VALUE ENGINEERING STUDY

Project # STP00-2009-00(004) PI No. 742870-
SR 920 from SR 54/Fayette to SR 3/US 19/Clayton
Fayette/Clayton County, Georgia

16 May 2013

PROPOSAL NUMBER: R-3.0

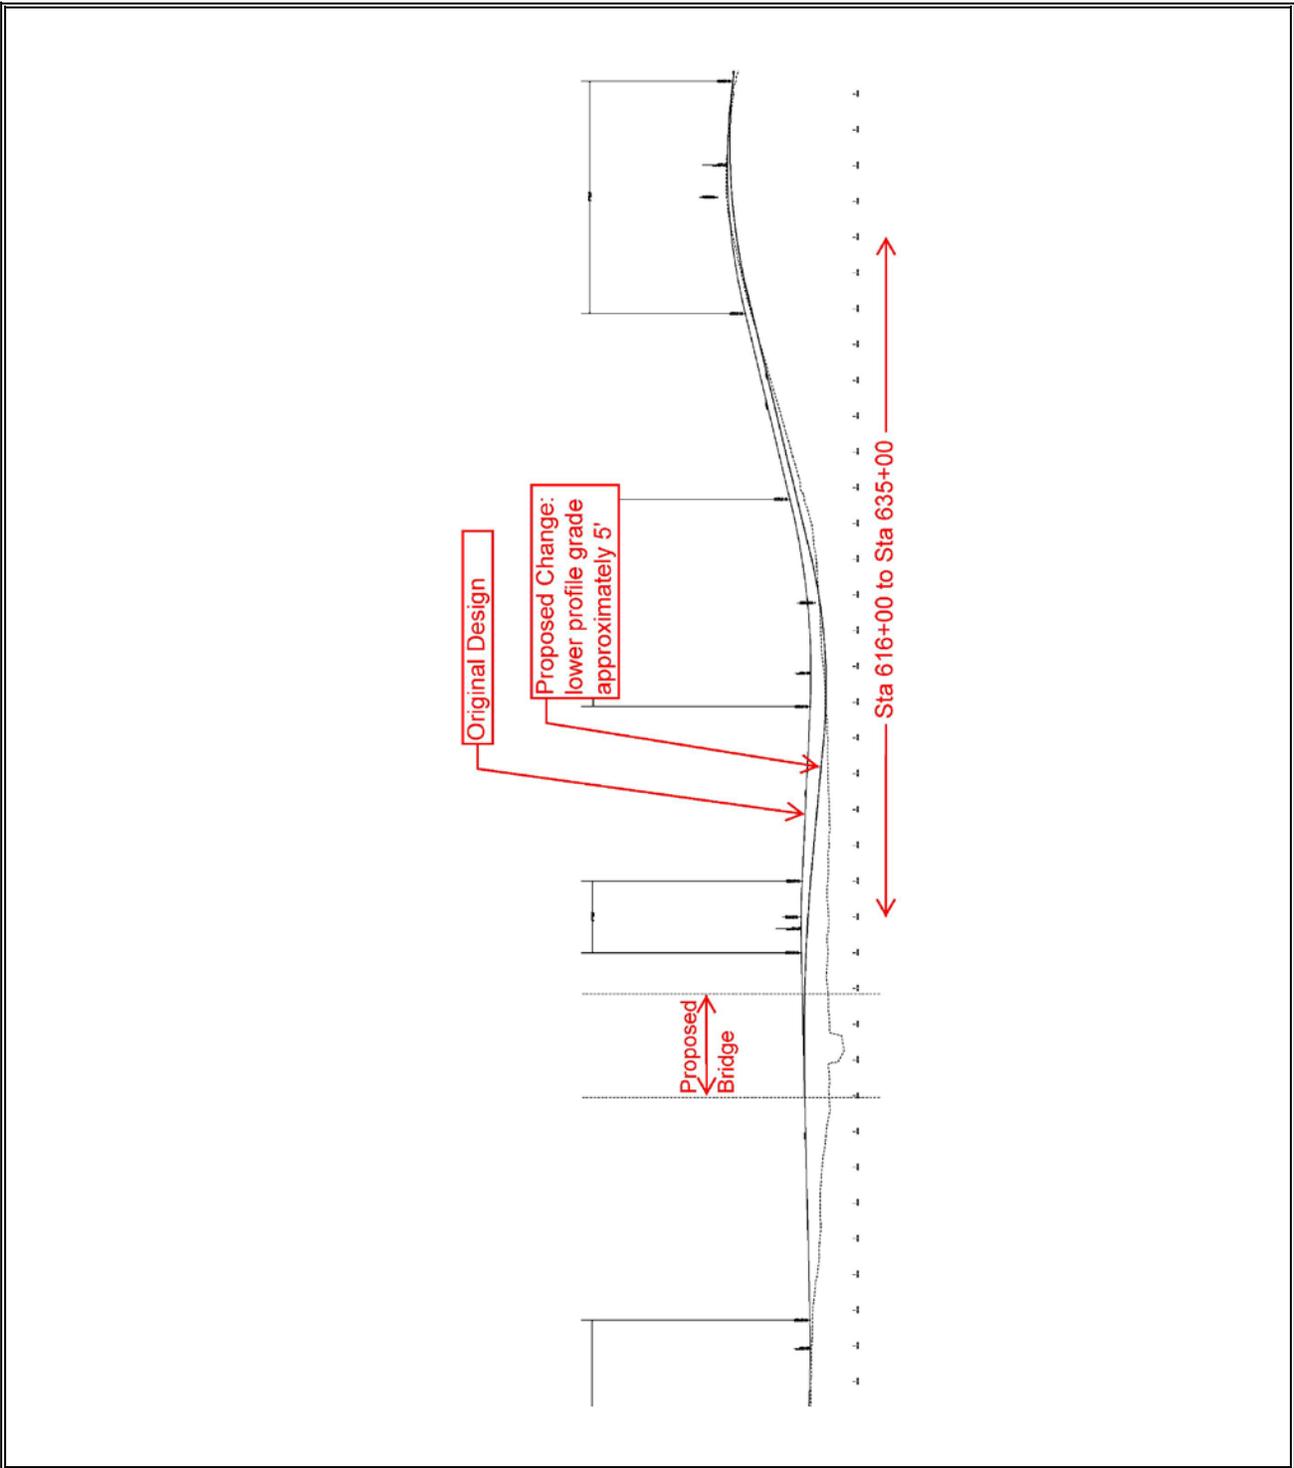
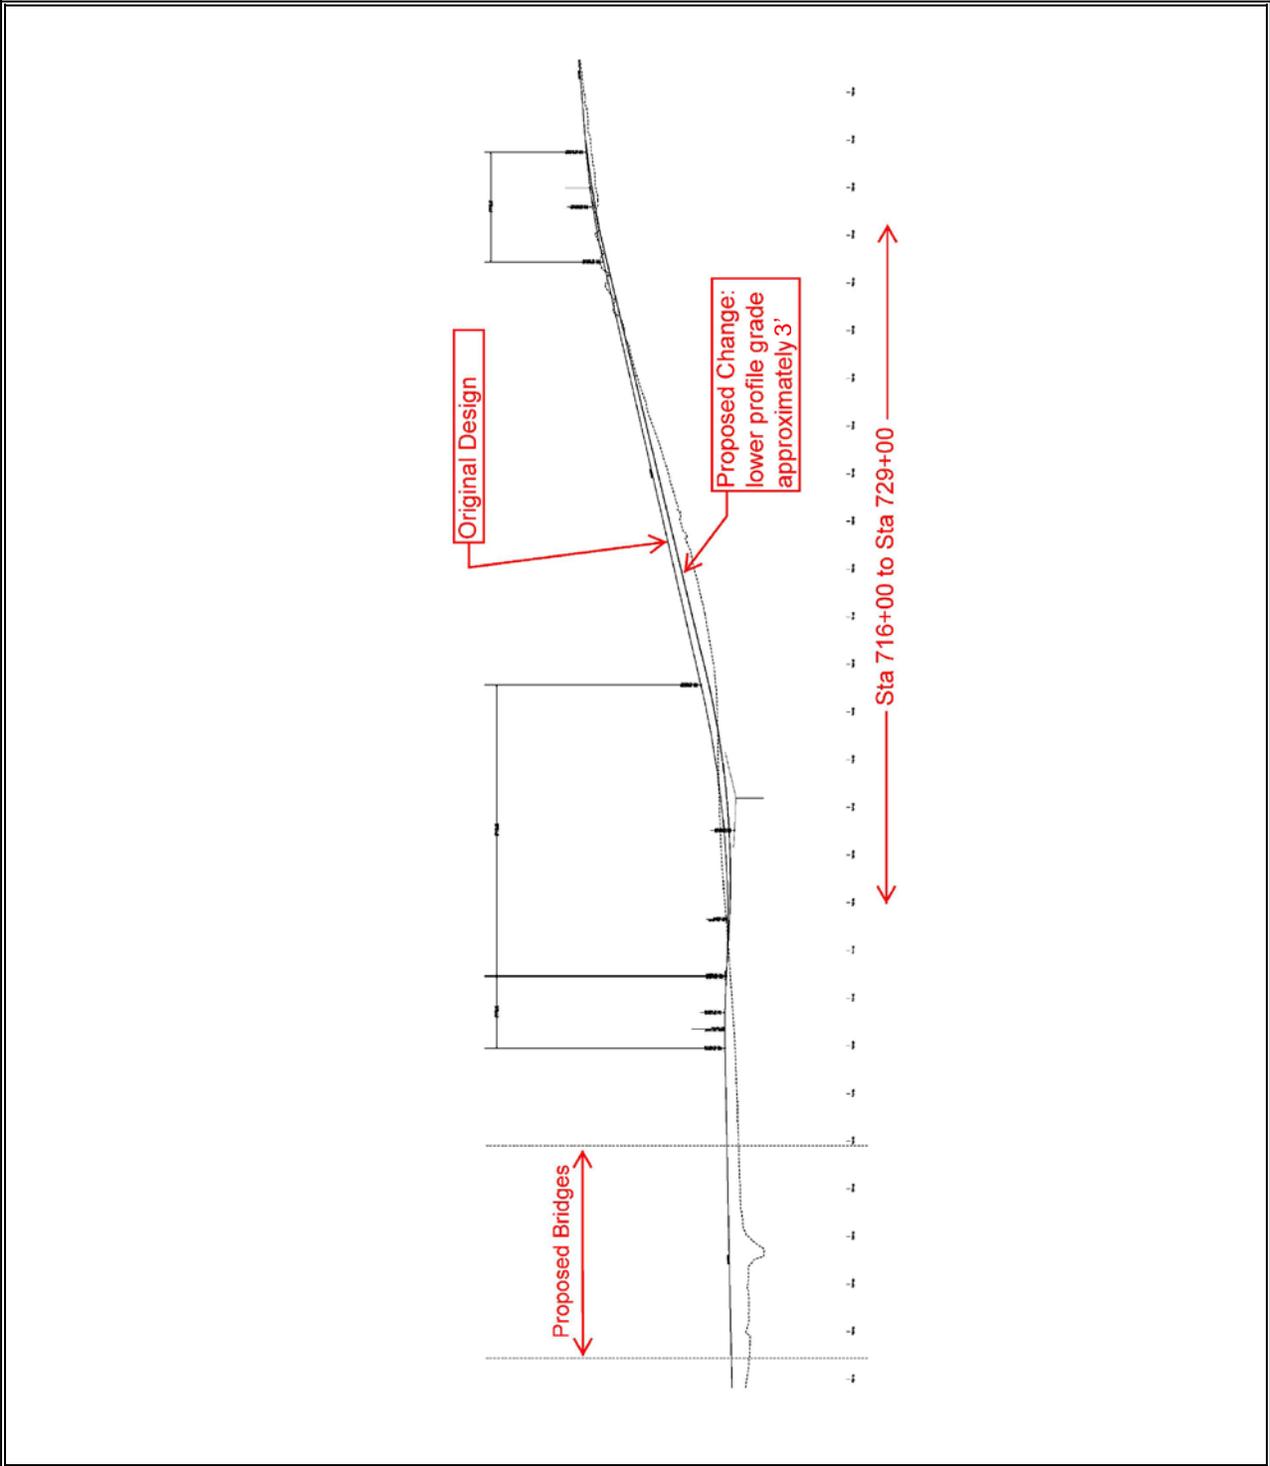
Summary of revise vertical profile design: Hold the minimum bridge elevation per the original design. Move the crest curve back station to the bridge. Increase down grade in order to lower the vertical curve between Sta 620+00 to Sta 626+00 by approximately 9 feet. After a sag curve continue with a 5 foot lower profile utilizing a 5.99% grade (same as original design) to form a vertical crest curve from Sta 633+00 to Sta 639+00 and match original design.

Summary of revise vertical profile design: Lower grades by approximately 3 feet within station limits.

R-5.0 Proposed Change
5 of 7

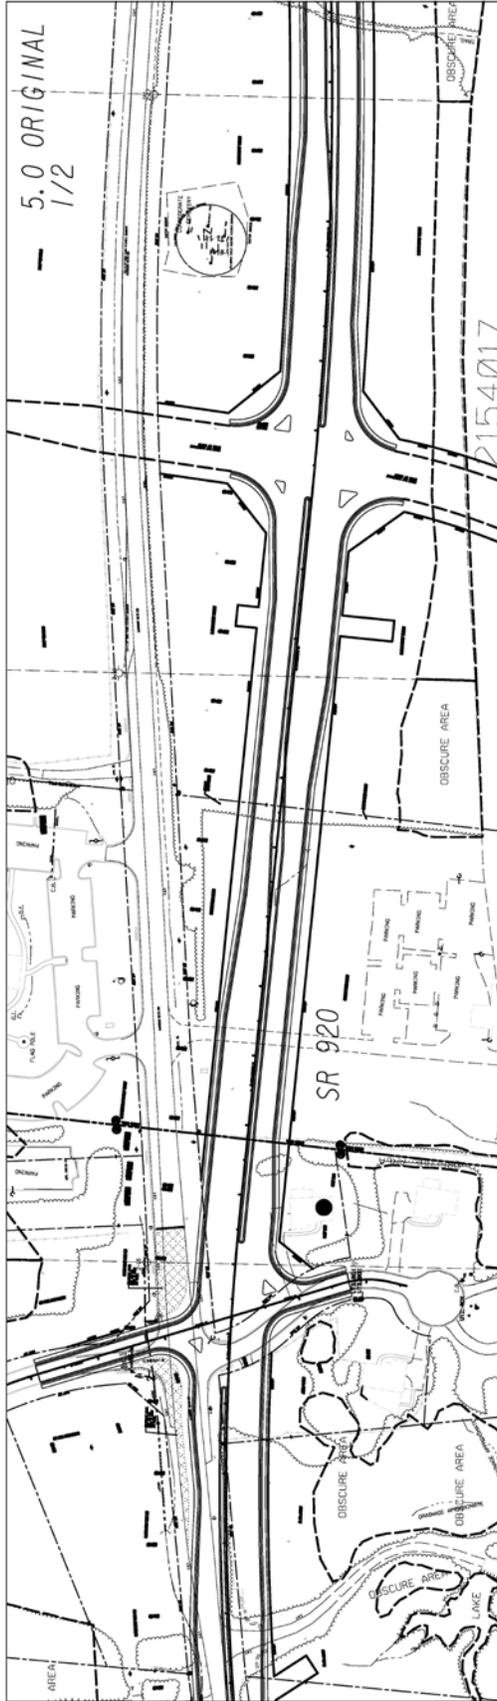
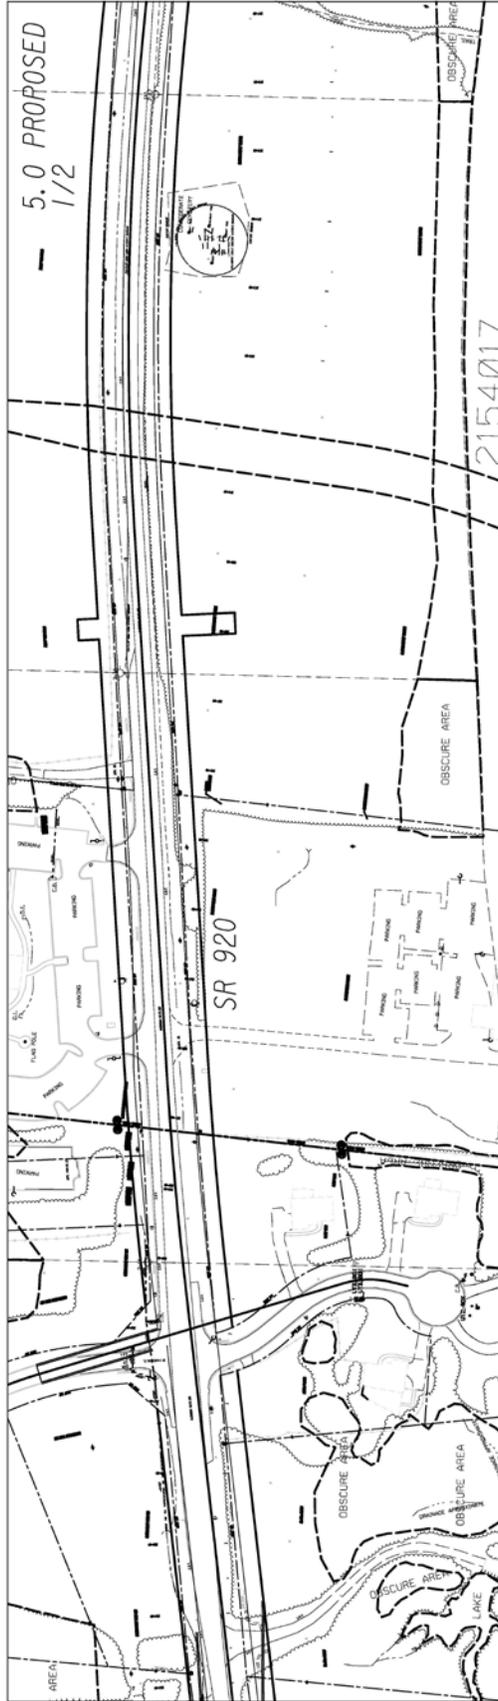
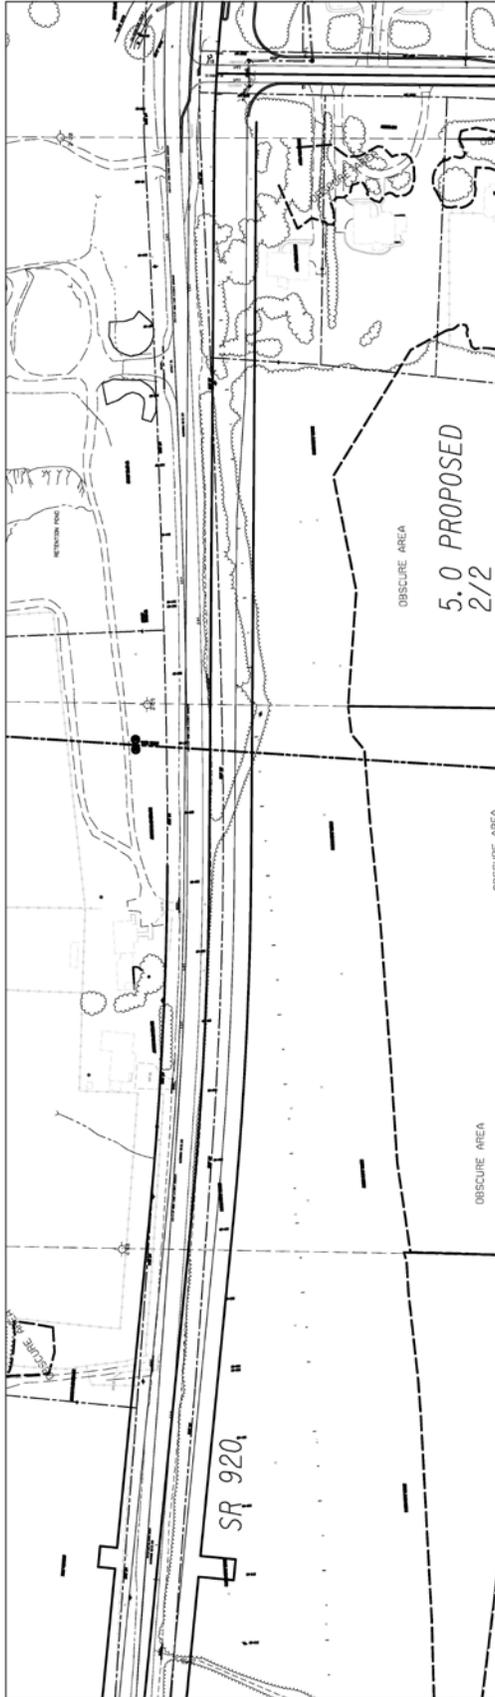
PROPOSED CHANGE: It is proposed to widen SR 920 on the existing alignment and shift the widening from North to South in order to avoid creating an adverse effect to the historic farm on the North side of SR 920.

R-6.0 Proposed Change
4 of 6

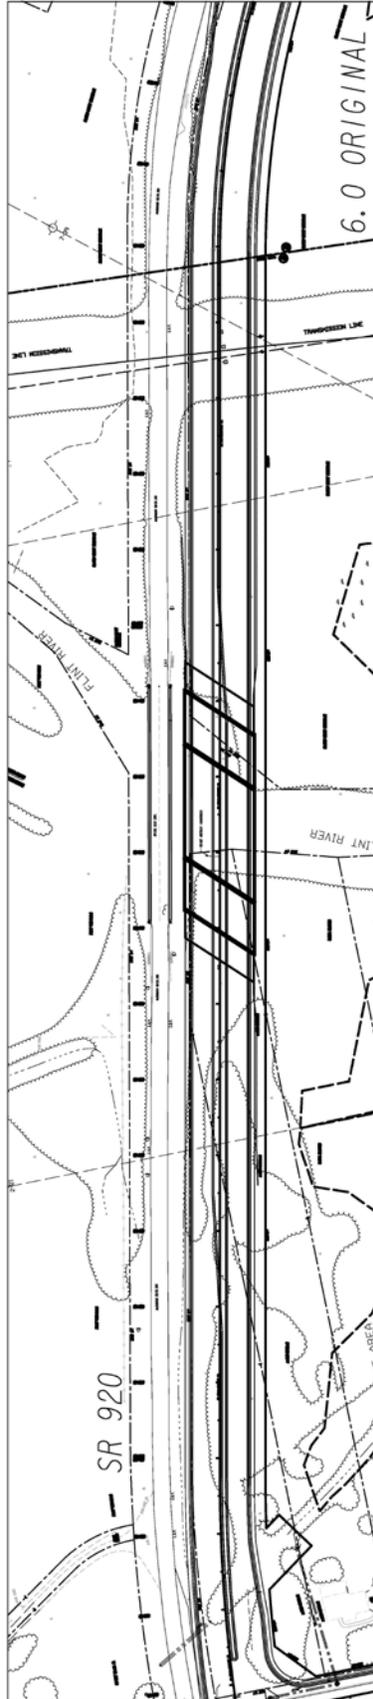
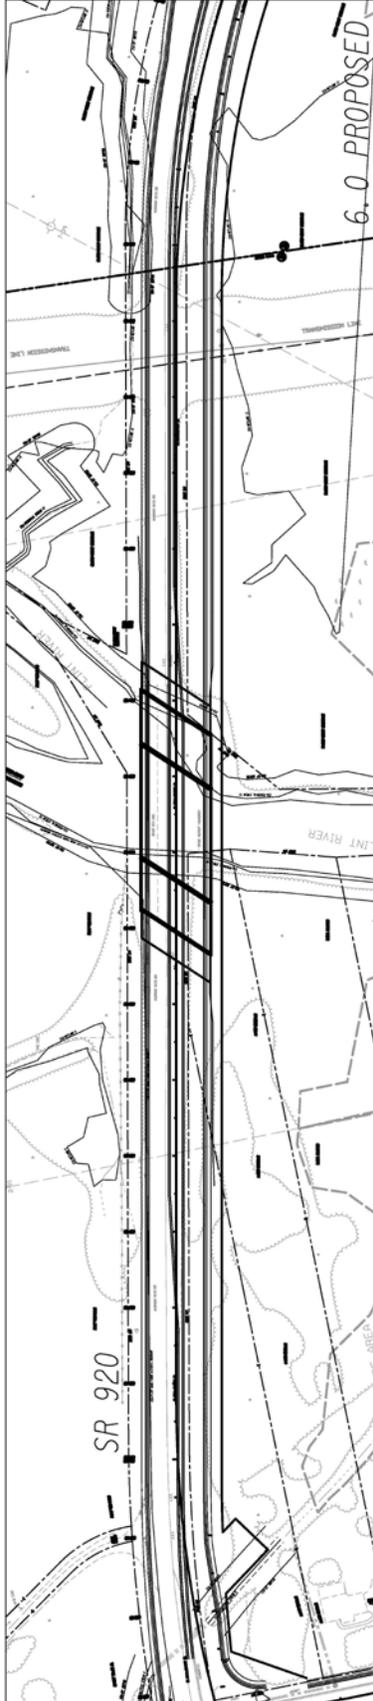
PROPOSED CHANGE: It is proposed to widen SR 920 South of the existing alignment and use stage construction to limit right-of-way and utility impacts.

PROPOSAL NUMBER: R-9.0

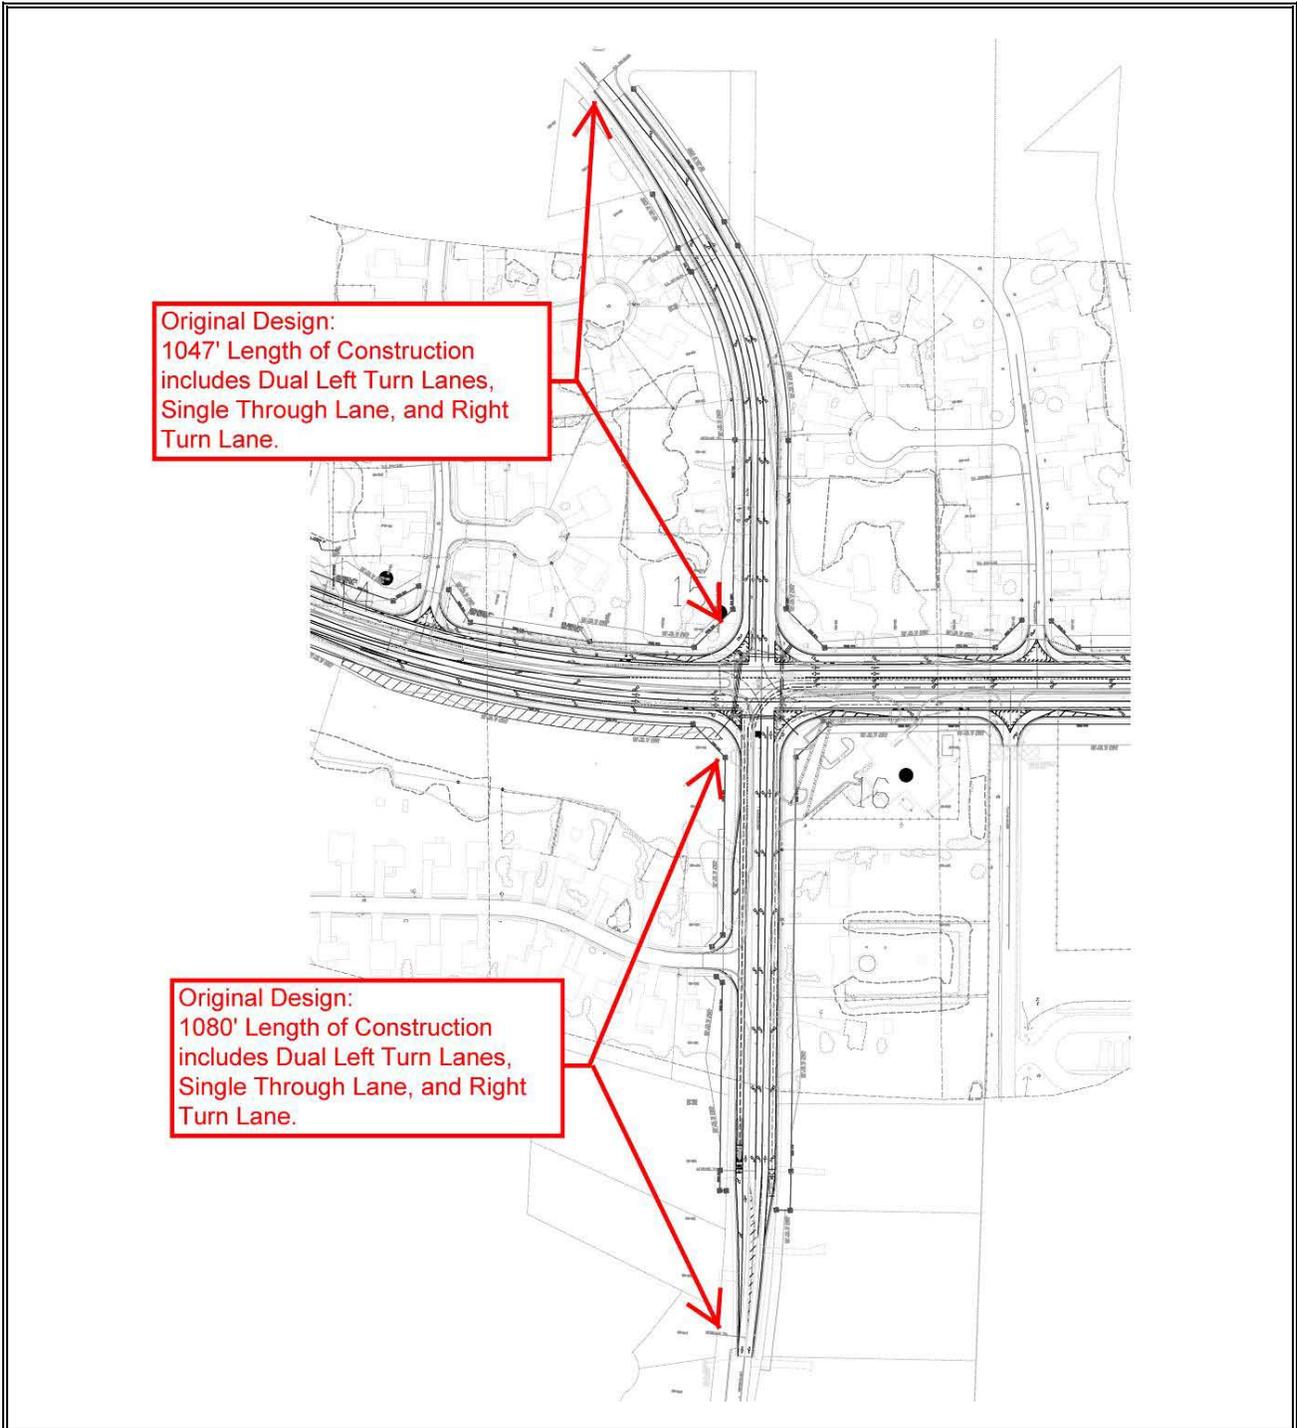
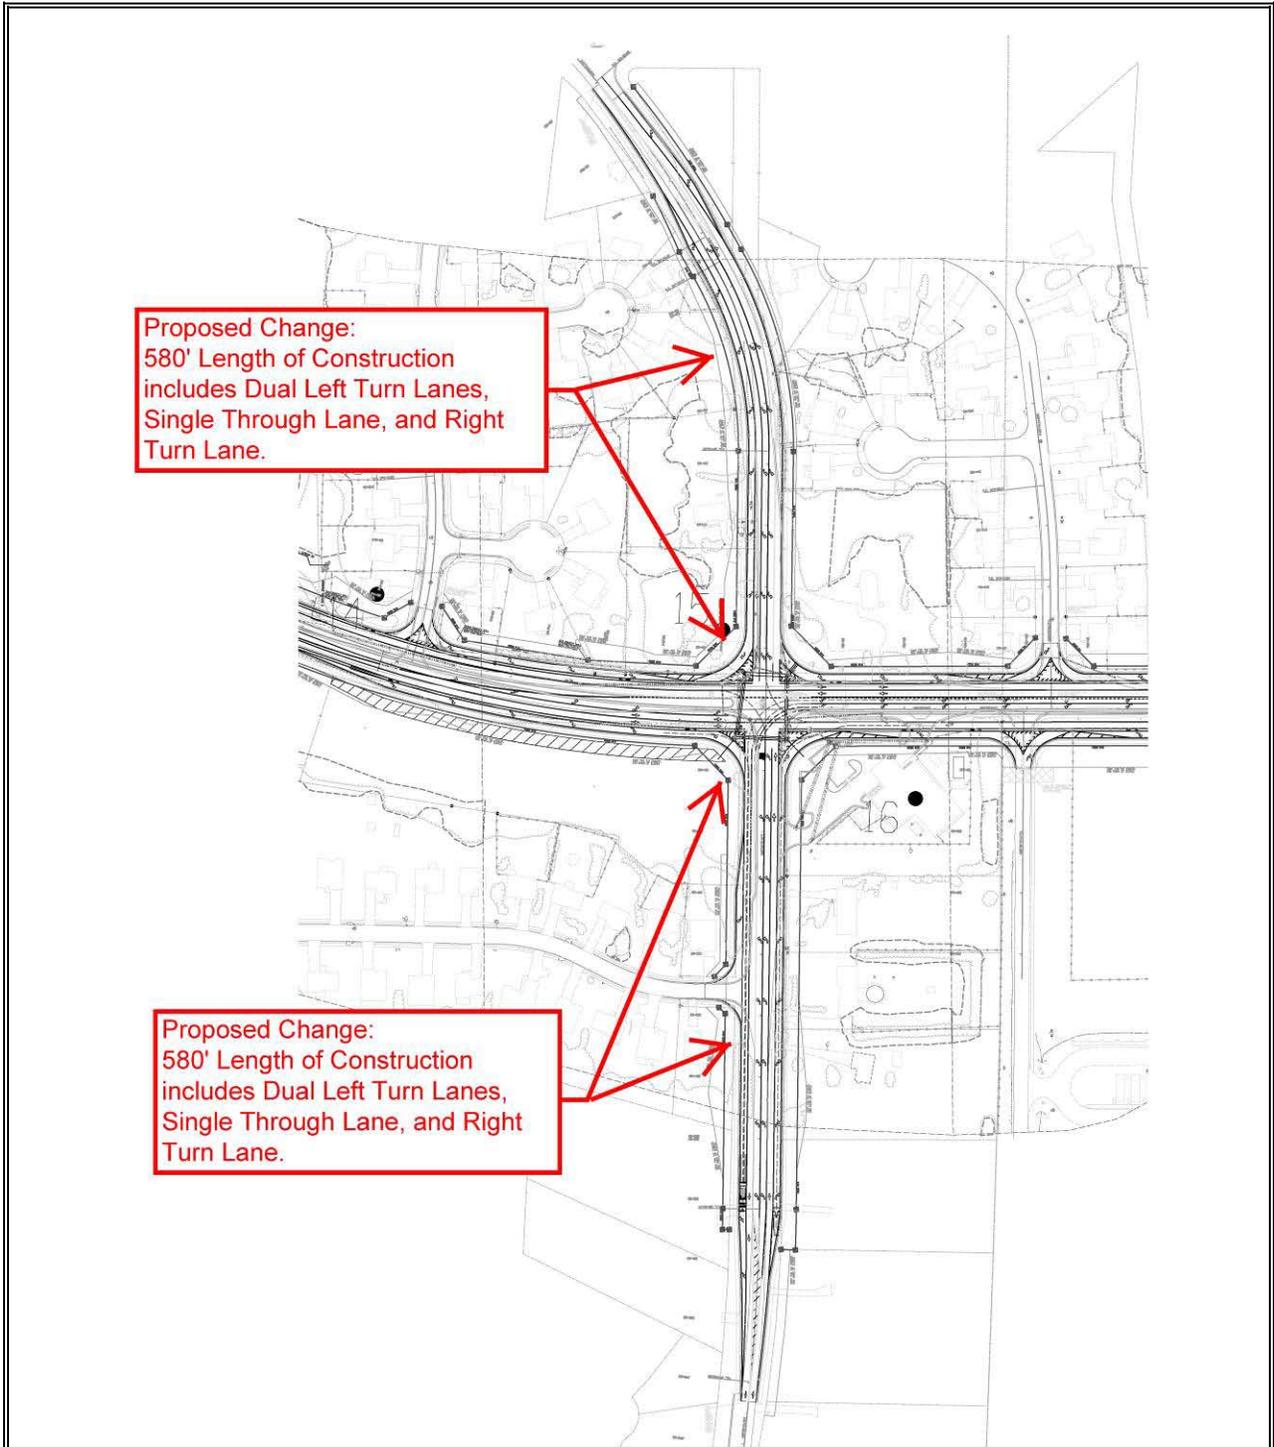
PROPOSED CHANGE: It is proposed to shorten the dual left turn and right turn lanes on each Panhandle Road approach to more accurately reflect the turning movement counts and adjusted vehicles per peak hour as reflected in the Synchro output data included in the February 2012 Traffic Analysis.
